# **URGENT Field Safety Notice**

### ABL90 FLEX and ABL90 FLEX PLUS

## - Risk of incorrect time and potentially biased results

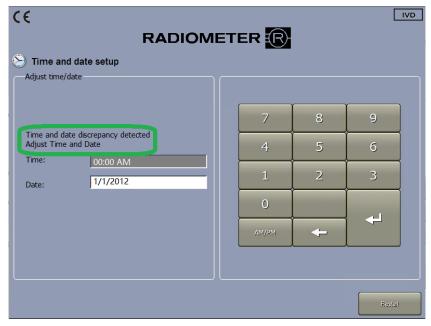
The software update ensures that the analyzer will detect any date and time discrepancy that may appear during a startup following an abrupt power break. When detected the analyzer will:

- Reset the date to 1/1/2012 and time to 00:00 (or earlier) and start running from there.
- Display the following screen prompt prior to full startup:

Time and date discrepancy detected Adjust Time and Date

• The operator must then adjust time and date and touch Restart to confirm and restart the analyzer.

If the analyzer shows the above screen during startup then adjust the time and date.
